HOPE CREEK GENERATING STATION
DOCKET NO. 50-354
DRAFT SAFETY EVALUATION REPORT
OPEN ITEM STATUS

DSEI Open Item No. 222 (DSEI Section 8.2.2.2)

DESIGN PROVISIONS FOR REESTABLISHMENT OF AN OFFSITE POWER SOURCE

FIGURE 8.2-2

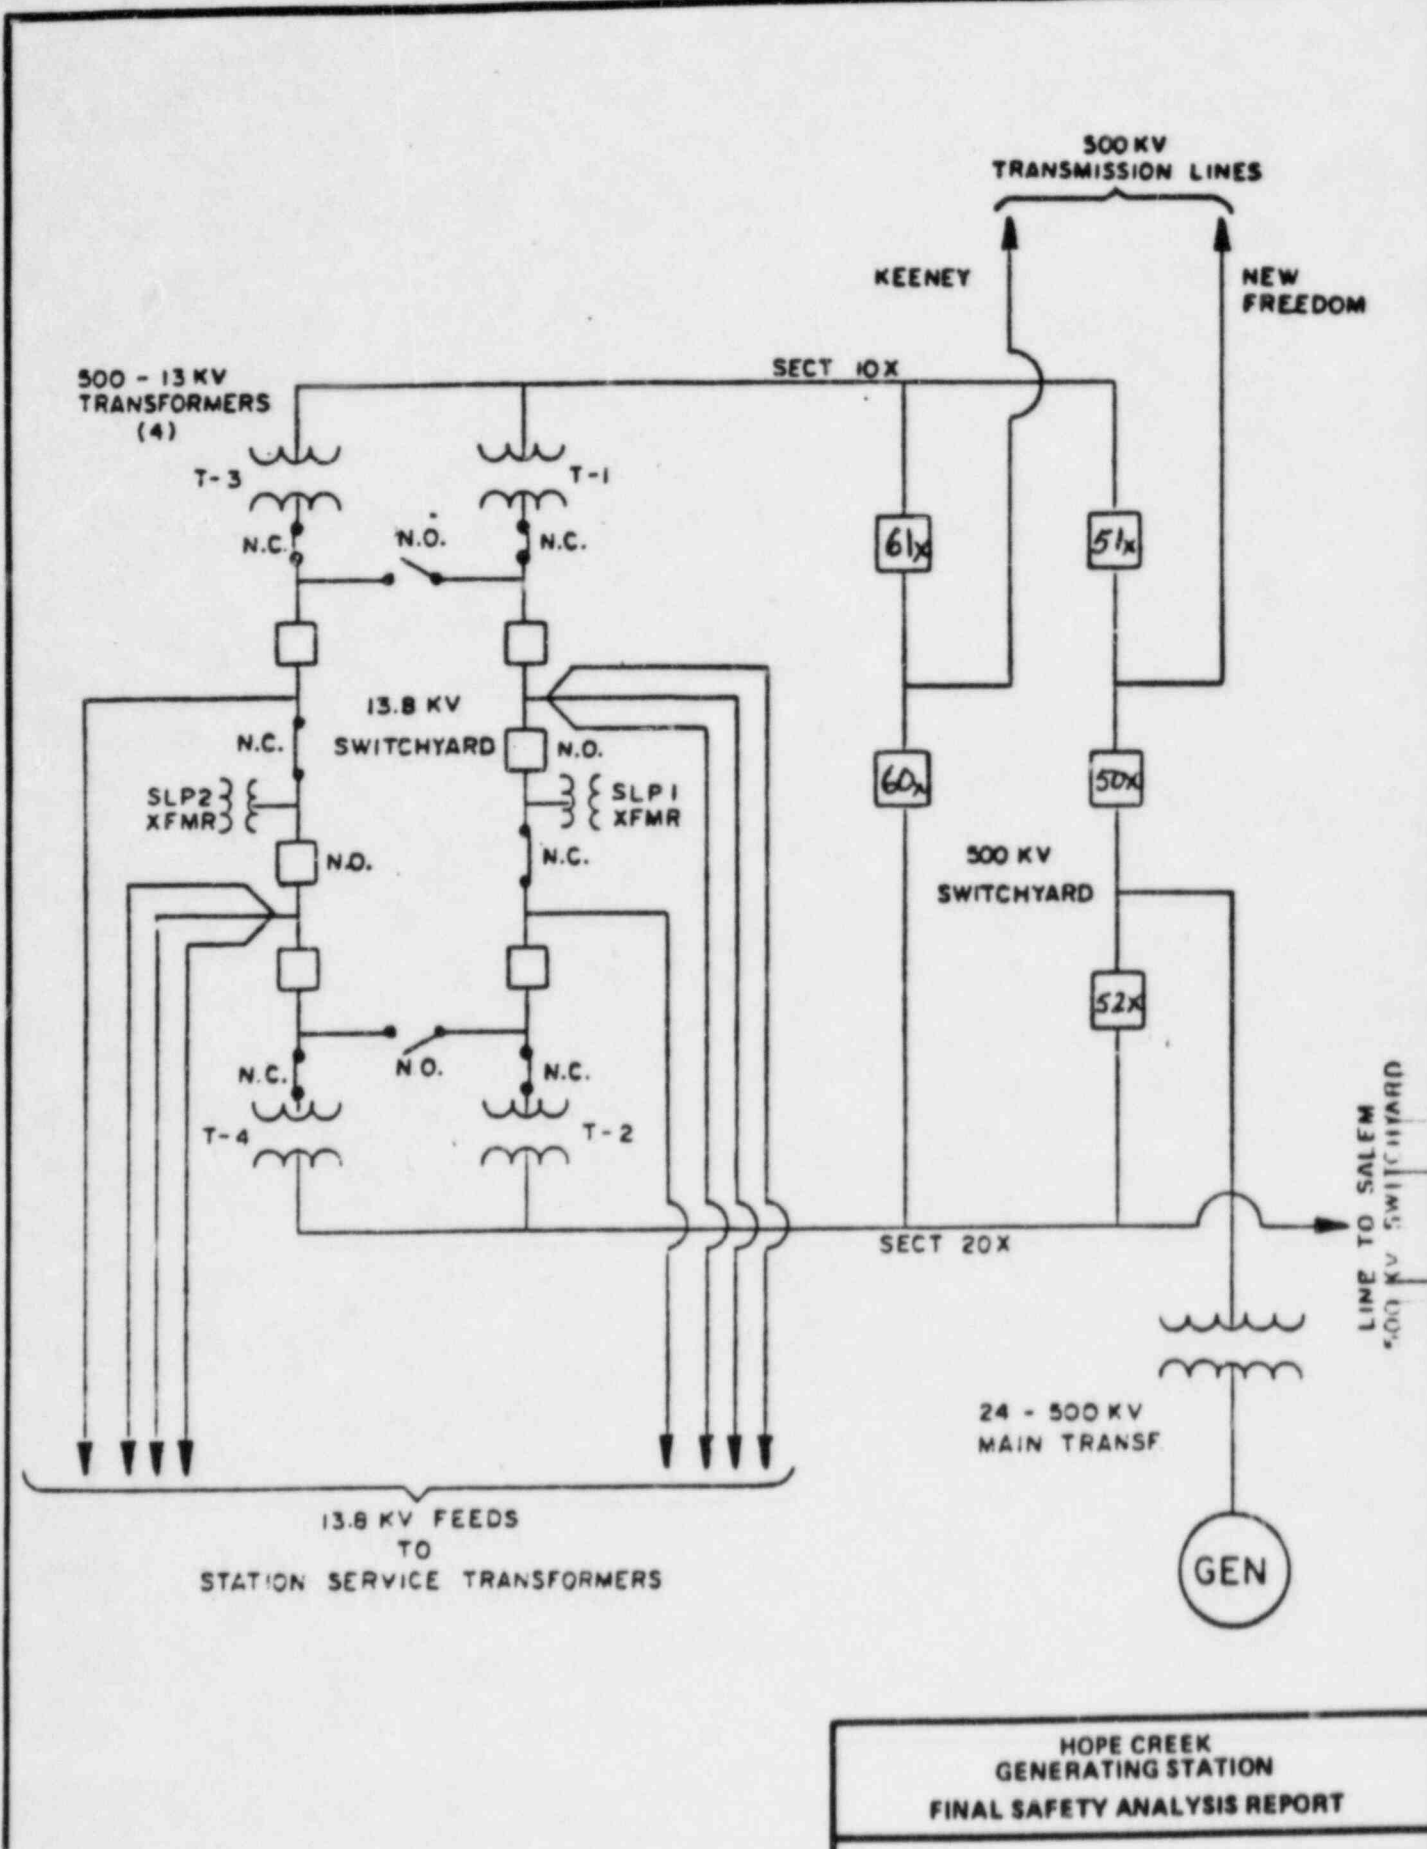
GDC 17 requires, in part, that each of the offsite circuits be designed to be available in sufficient time following a loss of all onsite alternating current power supplies and the other offsite electric power circuit, to assure that specified acceptable fuel design limits and design conditions of the reactor coolant pressure boundary are not exceeded. The description in the FSAR as to compliance with this part of GDC 17 is not sufficient to reach a conclusion of acceptability.

By Amendment 4 to the FSAR the applicant in response to a request for information, stated that in the event of relay operation, the relays can be reset and the equipment returned to service within one hour. This design provision description for reset of relays may be related to design provisions used for reestablishing an offsite circuit from the transmission system through the switchyard to the Class 1E system; however, the description by itself is not sufficient to reach a conclusion of acceptability nor is it responsive to the staff request for information.

FSAR section 8.2.1.4 and Figure 8.2-2 have been revised to provide the requested information.

The 500 KV circuit breakers are pneumatically operated and each breaker has sufficient stored air for a minimum of three operations without compressor actuation. The compressor motor is fed from the breaker A.C. distribution panel, which is provided with two independent A.C. circuits from the switchyard control house.

The control room and the switchyard control house have independent and simultaneous control of the 500 KV circuit breakers. The electric system operation center, located in Newark, N.J., has limited control of the line breakers 51x, 60x, and 61x and the tie breaker 50x, and no control of the generator breaker, 52x.

Restoration of the 500 KV lines would generally consist of the following procedural steps:

TITLE: SHORT CIRCUIT PROTECTION
 OPERATIONAL STATION
 FINAL REPORT
 PERMANENT RECORD
 OVERCURRENT PROTECTION
 SHEET 13 OF 20

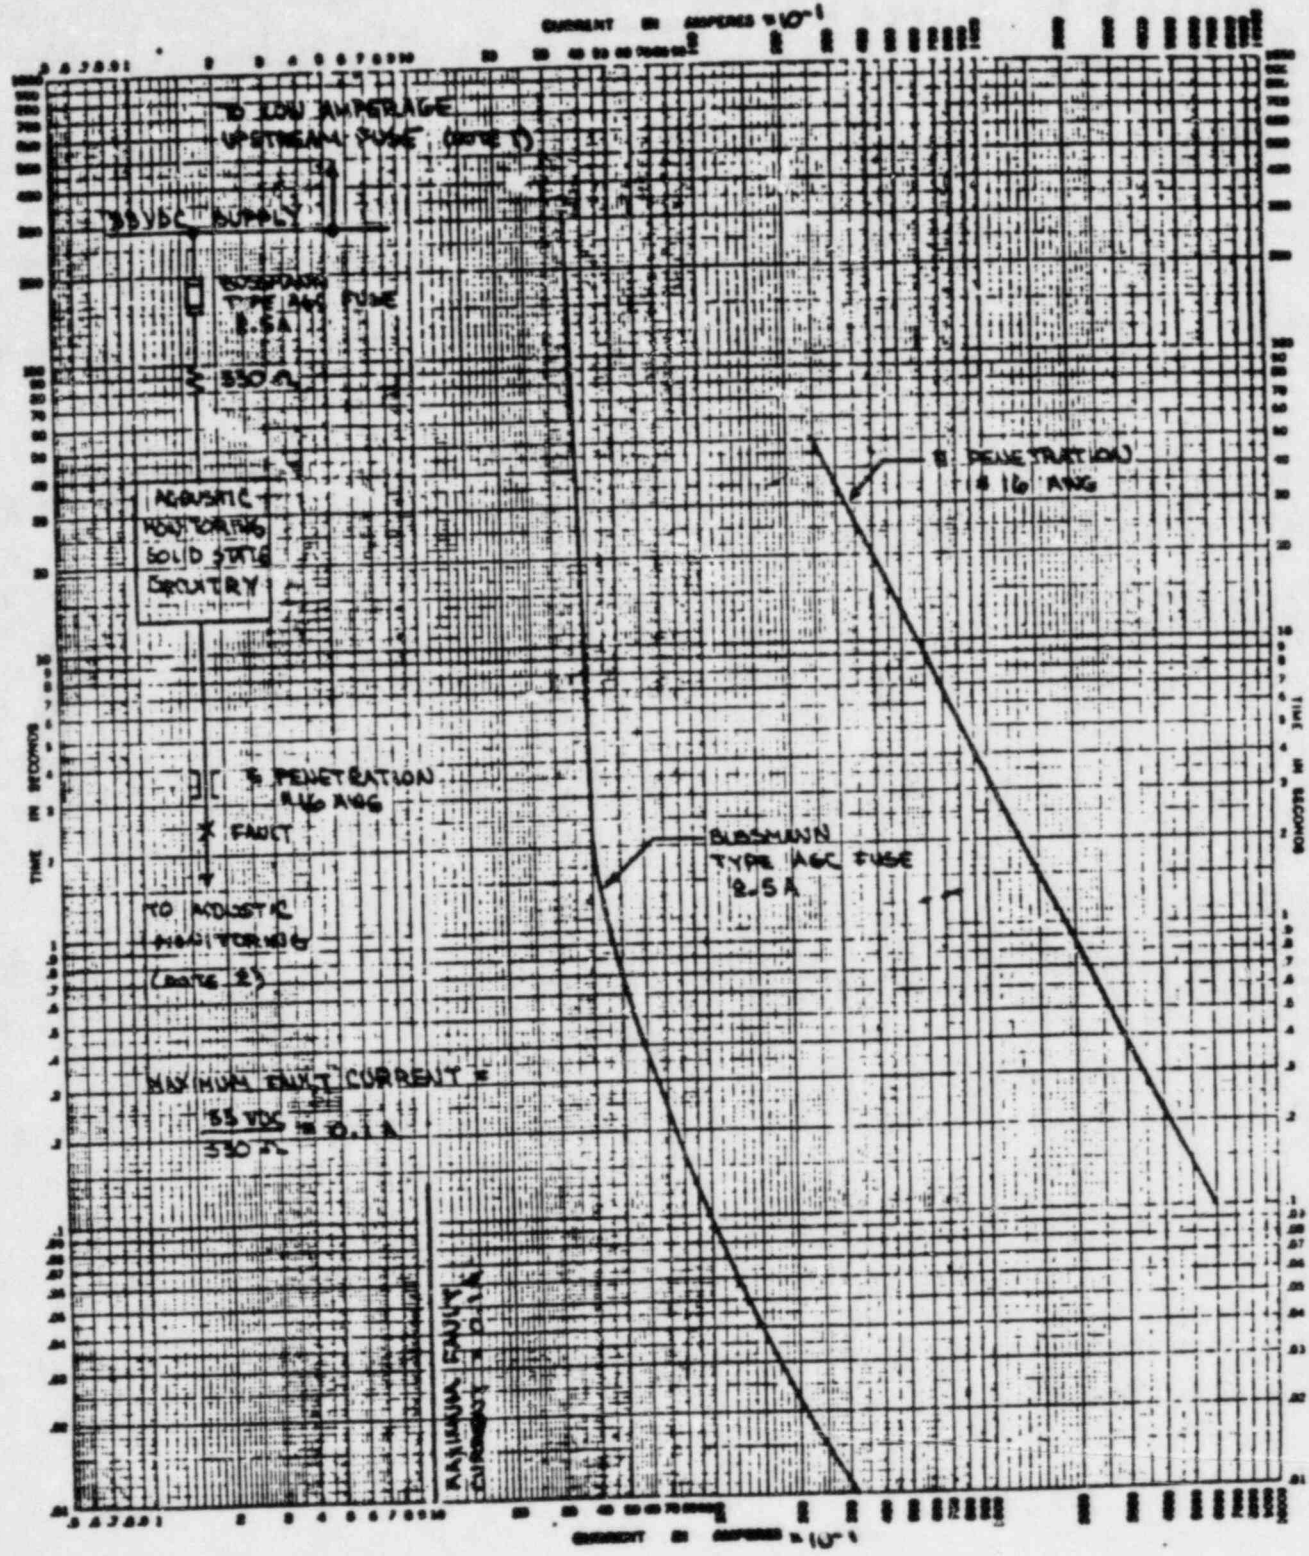
By Amendment 4 to the FSAR, the applicant indicated that coordinated fault-current versus time curves for representative penetration conductors and their protective devices are included in Figures 420.46-1 of the FSAR. Based on a review of these figures, the staff concludes that representative curves for motor differential relay, current transformer, and instrumentation circuits were not included in Figure 430.46-1. Inclusion of these circuits as well as other circuits such that the coordinated fault-current versus time curves is representative of all penetration circuits will be pursued with the applicant.

The response to Question 430.46 has been revised to provide additional fault current versus time curves.

- b. Coordinated fault-current versus time curves for representative penetration conductors and the protective devices are included in attached Figures 430.46-1.

The 1000 kc mil medium voltage penetrations associated with reactor recirculation pump motors, are protected by two Class 1E circuit breakers in series as shown on revised FSAR Figure 8.3-4. Section 8.1.4.12 has been revised to include this response. Figure 430.46-1 Sheet 21 is a typical coordination curve for a #16 AWG penetration for RTD and thermocouple circuits. The curves show that the instrument penetration is protected for the maximum short-circuit current.
